23 October 2012

DEXUS ESTATE INDUSTRIAL PARK PROJECT (MP 08_0259) – FUJITSU DATA CENTRE FACILITY – AMENDED LAYOUT

Figure 3: Data Centre Facility Site Plan – As Approved

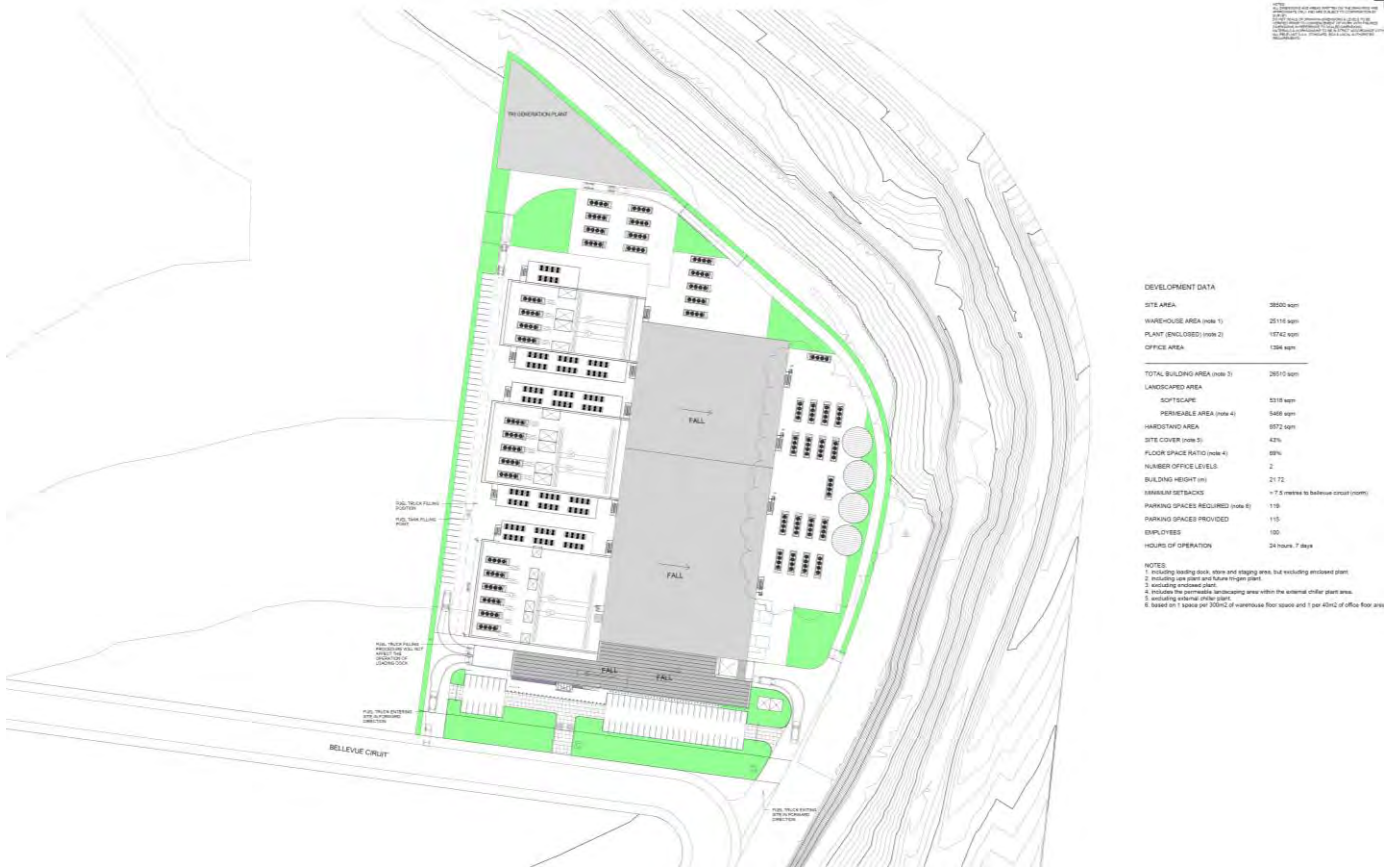
To meet the growing demand, Fujitsu is proposing to expand the Data Centre Facility. The planned changes involve:

- relocation of the Stages 2-3 data hall warehouse to the west of the approved location, and expansion to 4 levels, with 3 data halls on each level;
- relocation of the UPS plant buildings², with:

- a 3-level plant building attached to the eastern side of the existing Stage 1 data hall warehouse; and
 - a 5-level plant building attached to the northern side of the relocated Stages 2-3 data hall warehouse;

- expansion of the ancillary office to 3 levels; and
- relocation and augmentation of external plant, ancillary services and equipment, including:
 - a loading/storage/staging building attached to the southern side of the relocated Stages 2-3 data hall warehouse;

- a single level detached switchroom building to the north of the relocated Stages 2-3 data hall warehouse;
 - consolidation of the fire water tanks (from 4 to 2); and

- provision of additional car parking spaces and localised changes to the internal access roadways.

Figure 5: Approved Building Heights Plan

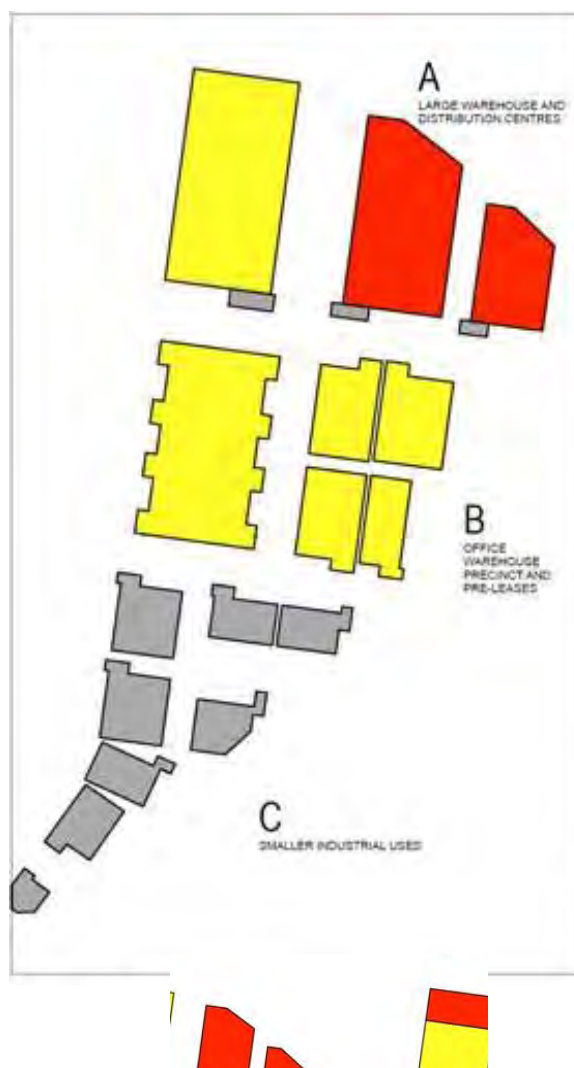
- the floor space ratio of the revised facility (ie. 103%) is higher than the approved Data Centre Facility (ie. 69%), which was also higher than the approved masterplan at the time it was approved; and
- the height of the revised facility (ie. 33.7 metres) is higher than the approved facility (ie. 22 metres), but is still less than the allowable height for the applicable lot (ie. 40 metres) on the masterplan (see **Figure 5**).
